GOVERNMENT OF MADRAS.

PUBLIC WORKS DEPARTMENT.

22nd September 1877, No. 766 W.

Veyarpanay Tank, Presidency Dis-
trict.—The explanation of the District
Engineer regarding the breach of —
communicated with remarks to the Re-
venue Department.

5. Original letters.
1. Plan.

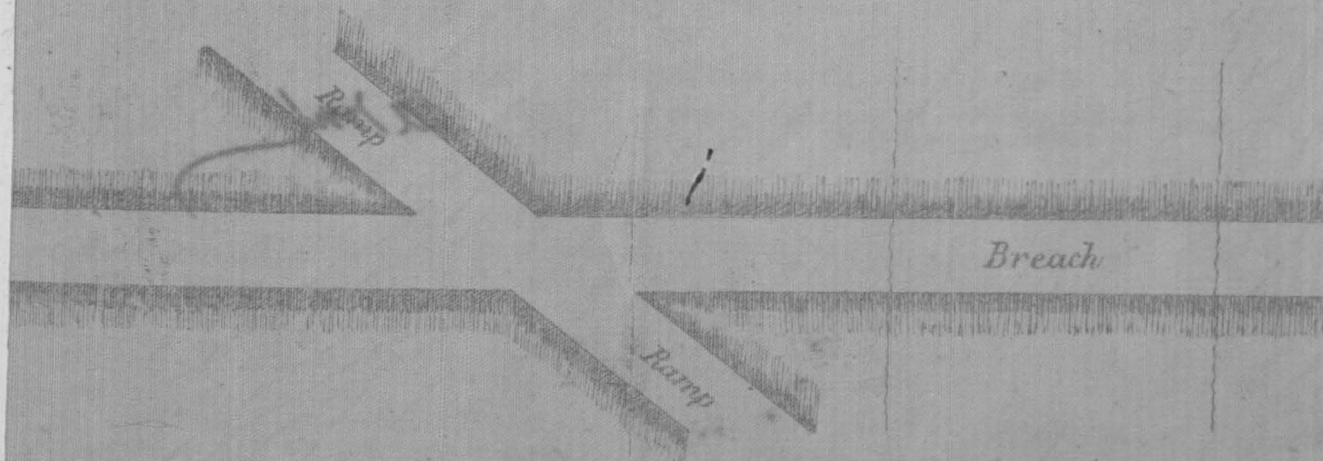
Reply to question c.—The breach occurred just on the west side of the ramp that is used for allowing cattle to pass over the bund; please see rough sketch.

1st.—The faulty construction of the tank bund; there is little or no foundation to the revetment, no puddle wall in rear of the revetment, the revetment is built nearly perpendicular instead of having a slope of $1\frac{1}{2}$ or $1\frac{1}{2}$ to 1. The sectional area of the bund is very inadequate considering the bad nature of the soil it is made with; the soil is of a salty and spongy nature. Cross section of breach forwarded.

2nd.—I beg to point out that I consider the ramp on the inner side of the bund was one of the chief causes of tank breaching in that particular place, as the ramp acted as a groyne during the time the high westerly winds prevailed.
